**Subject:** Response to Request for Additional Information Regarding License Amendment Request For Spent Fuel Storage Pool Criticality Analyses (CAC No. MF9996; EPID L-2017-LLA-0303)

**SERIAL HNP-18-003**

**RESPONSE TO REQUESTS FOR ADDITIONAL INFORMATION**

**SHEARON HARRIS NUCLEAR POWER PLANT, UNIT 1**

Figure 1  
Radial Fission Distribution for PWR Spent Fuel (~46 GWD/MTU, reference case)

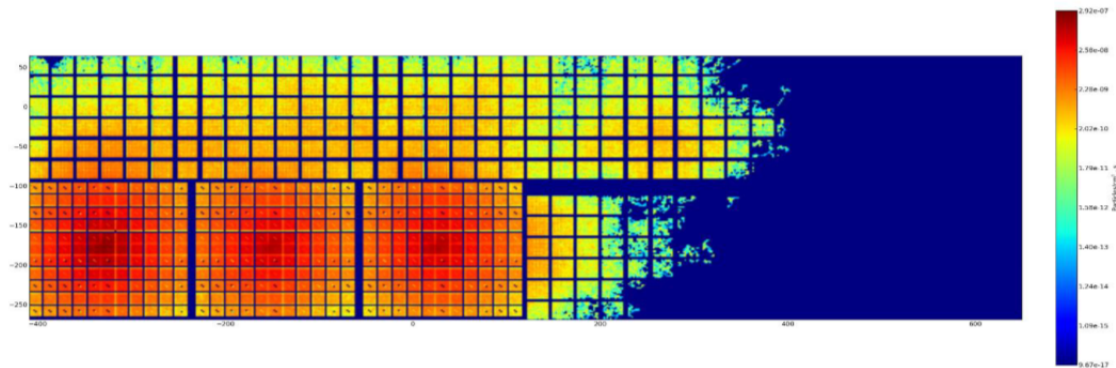
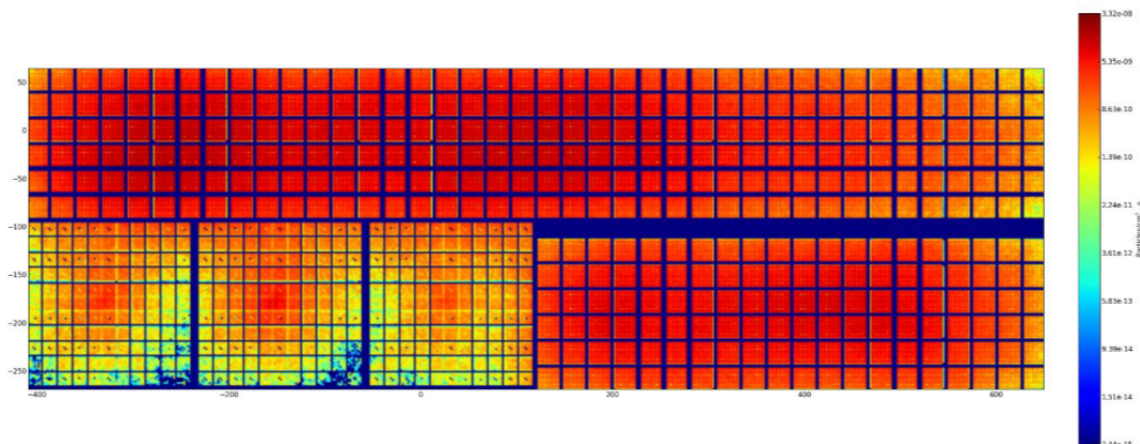
- e) The Attachment 5 licensing report explains, in Section 4.2.3.7, that the spent PWR fuel was evaluated at a burnup that leads to an infinite array of PWR storage racks, with the PWR fuel loaded in all cells, yielding the same reactivity as an infinite array of the BWR racks with Metamic rack inserts, fully loaded with the design basis BWR fuel. The intent of doing so was to avoid a calculation in which the calculated k-effective is dominated by the higher reactivity PWR fuel rather than providing any meaningful information about the interface between the PWR and BWR storage racks. The NRC staff understands the intent, but this approach of reducing the reactivity of the PWR fuel relative to the maximum licensed reactivity also has the effect of reducing a potential neutron source adjacent to the BWR fuel. Therefore, the NRC staff requests the following clarifications:

1. Please describe how much the reactivity of the PWR fuel used in the interface evaluations was reduced relative to the PWR fuel from the design basis criticality calculations for the PWR storage racks, or provide information on the reactivity impact due to the presence of higher reactivity design basis PWR fuel models as a boundary condition to the BWR racks.

- 1) The reactivity effect of the change in burnup and an evaluation of the reactivity impact of the PWR racks is provided in this response. As has been previously discussed, the PWR rack has been evaluated under a separate application. However, the results of that evaluation provide the loading curve which yield a burnup of about 42,380 MWD/MTU for 5.0 wt% PWR fuel. The PWR fuel considered in the application considers a burnup of about 46,000 MWD/MTU. The reactivity difference between the two cases in an infinite array of PWR fuel is about 0.0102 delta-k. This difference is of little relevance to the determination of the impact of the interface on the analysis of the BWR racks with Metamic inserts because the reactivity of the racks is dominated by the fuel in the center of the racks; this is especially shown by analysis for the BWR racks with Metamic inserts by the evaluation of alternative missing insert locations (see LAR Attachment 5 Table 4.A.4). Finally, fission distribution plots may provide some additional information to show these points. For this purpose, two figures are provided. Please note that these figures are based on normalized results and therefore the absolute values should not be compared. Rather, of interest is the relative values within each plot. In Figure 1 below, the fission distribution is shown for the SFP analysis case used in the interface evaluation. The BWR racks clearly are more reactive in the SFP geometry while also showing that the reactivity is well dominated in the center of the rack. In Figure 2 below, the PWR spent fuel burnup is changed to match that of the PWR burnup limit (increases PWR spent fuel reactivity by about 1% delta-k). It can be clearly seen that the reactivity of the PWR racks now dominates the SFP, as expected.

Furthermore, it can be seen that the maximum reactivity in the BWR racks is still dominated in the center of the BWR rack.
